CERTIFICATE OF THE SECRETARY OF ENERGY AND ENVIRONMENTAL AFFAIRS  
ON THE  
ENVIRONMENTAL NOTIFICATION FORM

PROJECT NAME : Columbus Avenue Seawall Reconstruction  
PROJECT MUNICIPALITY : Salem  
PROJECT WATERSHED : Atlantic Ocean – Juniper Cove  
EEA NUMBER : 16445  
PROJECT PROPONENT : City of Salem  
DATE NOTICED IN MONITOR : September 22, 2021

Re: Response to Comments – EEA 16445  
Columbus Avenue Seawall Reconstruction Project  
46 Columbus Avenue, Salem, Massachusetts

**Figure 1: Schematic Analysis of Wave Reflection from the Columbus Avenue Seawall**

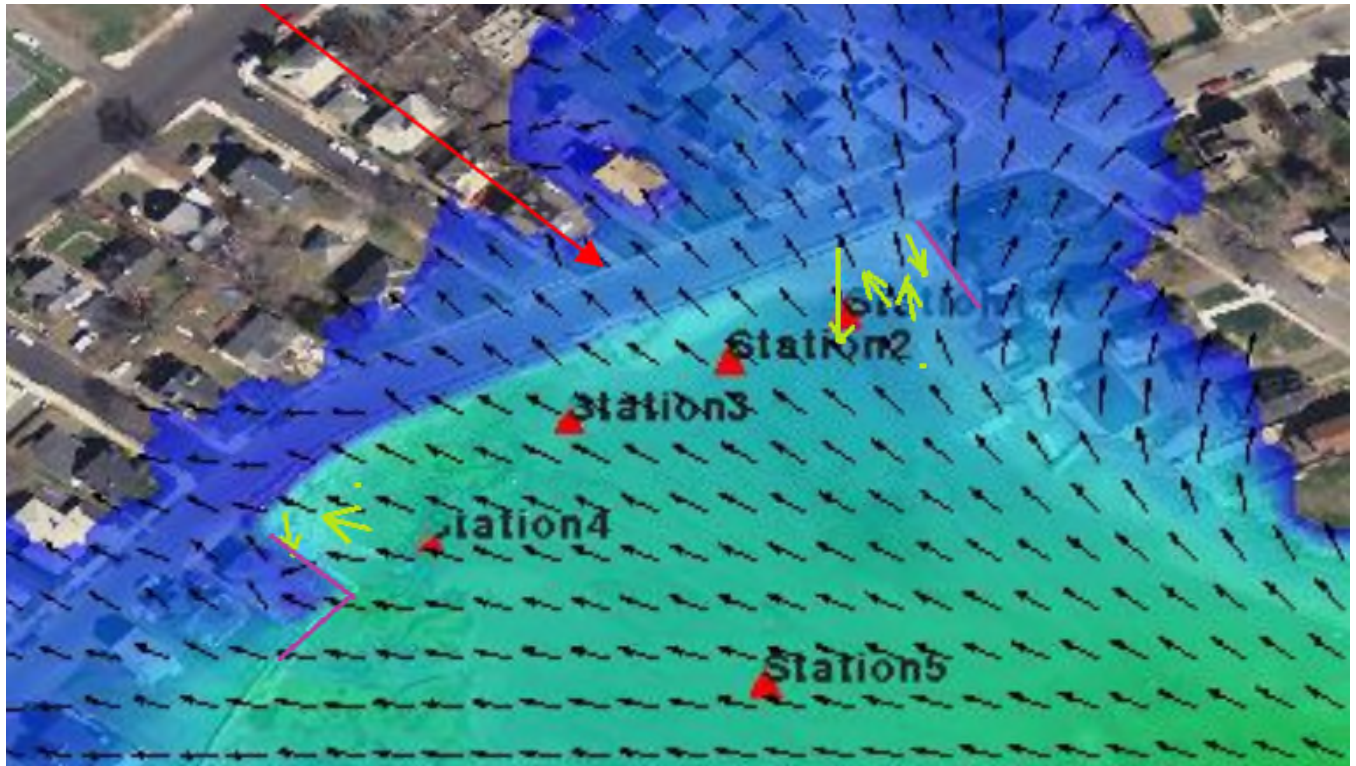
With the new wall being raised approximately 2' with added strength, we are concerned that deflection from storm surge will flood at each corner. We are imagining this new and taller wall generating significant 'bounce' and causing flooding at each end. During the 2018 storms, the northeast corner of the wall at Columbus Ave and Bayview experienced severe flooding. Some residents had to evacuate their homes for many months to reconstruct. At the northwest corner at 44 Columbus Ave as well as 40, 38, 36 and 34 Columbus Ave all had their backyards flooded in knee deep water. If it were not for efficient sump pumps there could have been serious damage..we barely escaped.

tie-ins. There are several issues related to this. The first is finding some financial solutions/tools to assist abutters to raise their sea walls to match the height of the new wall. So far we have not had any success. Secondly, if we were to find funding to assist abutters, does the sea wall at the northwest corner have the structural integrity to handle significant added weight as the wall gets built up? Thirdly, how far down do we need to extend the new height of the sea wall? Do we go all away to 30 Columbus Ave? What about on the northeast side? Building up these walls will go a long way in providing safety and water containment. We need more information on this.

4-The northeast corner as previously mentioned had severe flooding and damage during the 2 big storms in 2018. At 30 Bayview Ave, the tie-in wall that is there currently is the exact same wall that exists now which we think was built in the 1930's. In a similar event, with only a 10' tie-in of the new wall, water will pour into 30 Bayview Ave and throughout that entire corner where several homes were severely impacted. We don't think this project plan is complete until these abutter issues and potential flood events are addressed and thought through.

The following includes a summary of the qualitative analysis for the wave reflection/redirection caused by an increased seawall height on adjacent structures. Relative to flood inundation (i.e., flooding due to storm surge and tides but not including wave effects), raising the seawall is unlikely to increase the flood inundation of the adjacent properties, since flooding can enter this area by overtopping the existing residential seawalls. Similarly, elevating the seawall is not expected to affect the flood depth or flood limits along Columbus Avenue (currently both categorized as AE zone) since these areas are flooded from other flood entry points.

Elevating the seawall could increase the reflected wave heights (see yellow arrows in **Figure 1**). The influence of the reflected waves on the adjacent properties is uncertain.

At the southwest corner, current ground elevation close to the toe of the seawall is approximately 8 to 10 feet NAVD88, indicating a breaking wave condition during the 100-year storm event. The breaking wave condition is highly turbulent, so the influence of reflected waves and wave rundown is difficult to predict.
